## Service information

### Symptom

Steam/water leakage from stand

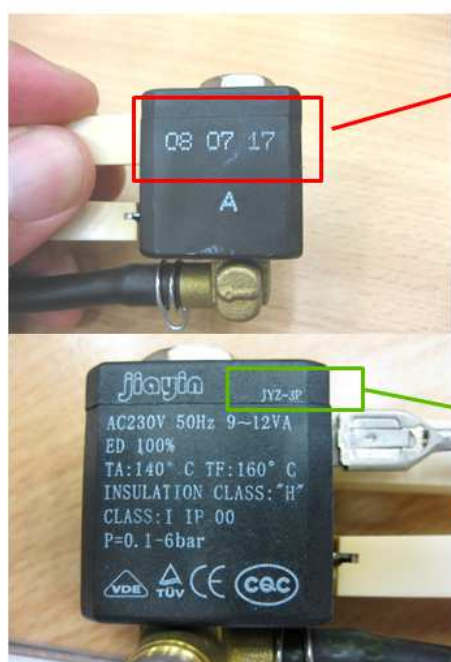
Cracks at boiler electro-valve will lead to steam/water leakage.  
The crack is the resultant of torsion stress during assembly process.

Please replace the defective electro-valve. Service code: 4239 017 10901.

New electro-valve with improved design is introduced since 2010 July 23. The new part can be identified via the date code on the component body. Refer below picture.
